FIELD SAFETY NOTICE / PRODUCT NOTIFICATION

Subject: Brainlab Radiation Treatment Planning Software:
 For use in the Brainlab software, image sets other than CT must only contain the same pixel values calibration for all images/slices of the set.

Product Reference: iPlan RT Image (below v.4.1.2) / iPlan RT; and BrainSCAN (discontinued).

Brainlab Identifier: **CAPA-20150727-001458**

Figure 2 Sagittal reconstructions of axial PET images (without SUV) illustrating the possible effect: Left - display of supported set with uniform calibration. Right - display of unsupported set containing varying calibrations.

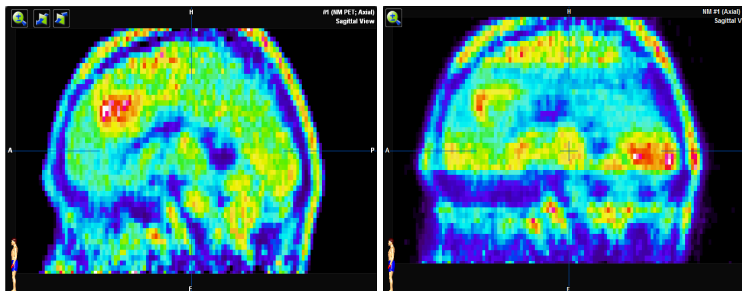
Figure 2 below illustrates how this effect could influence the appearance of e.g. a sagittal reconstruction of an unsupported axial PET image set. The areas of the highest and lowest activity might seem to be located in a different region of the reconstruction.

- Except for CT and PET used with SUV, only load and use image sets in iPlan RT / iPlan RT Image that have the same pixel value calibration for all images of the set.
- Before using image datasets loaded into the Brainlab Radiation Treatment Planning Software, always compare the images displayed in the Brainlab application to the images as displayed by the imaging device (scanner), e.g. using a different display media approved and available to the hospital other than the Brainlab software. Delete and do not use the image sets within iPlan RT in case any deviation is detected and contact Brainlab support.

Figure 3 Example of axial PET images (without SUV) illustrating the possible effect:

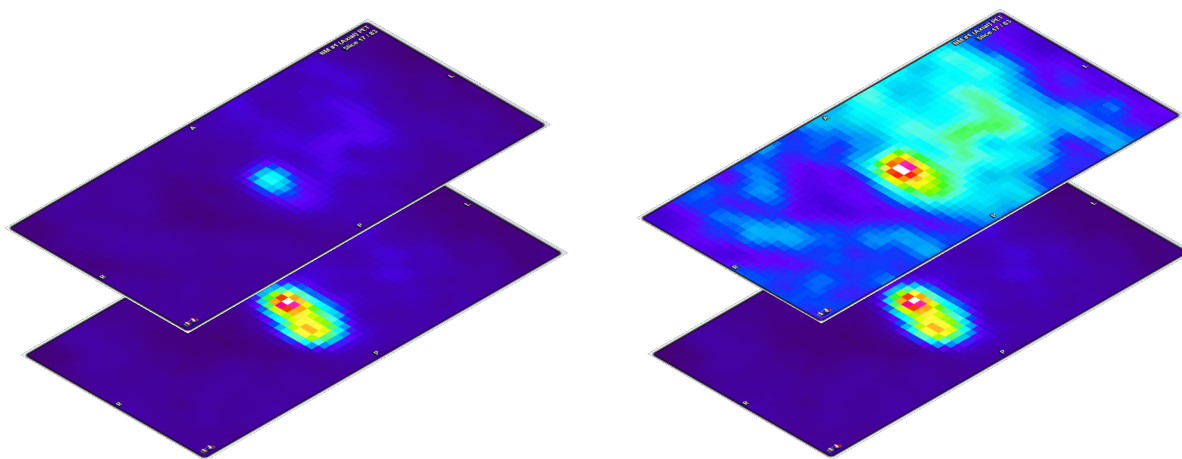
Usually the same calibration is applied to all images of one image set, but in some cases this might be set up differently at the imaging device. If *Rescale Slope/Intercept* differs in between slices of one set, the image set is not supported by the Brainlab planning software except for CT and PET used with SUV. When using such an unsupported image set with the Brainlab software, areas in different slices that would have the same physical or anatomical properties when displayed by the scanner using varying calibrations, might have different values in the Brainlab software due to the uniform calibration to all slices (refer to Figure 3).

Left - display of supported slices (uniform calibration). Right - display of unsupported upper slice (varying calibration).

Note: In such an unsupported PET, in the reconstruction (see Figure 2) the area of the highest activity might appear to be located in different regions (other slices of the set) - in comparison to the display by the scanner using varying calibrations - whereas within each single image slice the areas of the highest and lowest activities still remain at the same place.
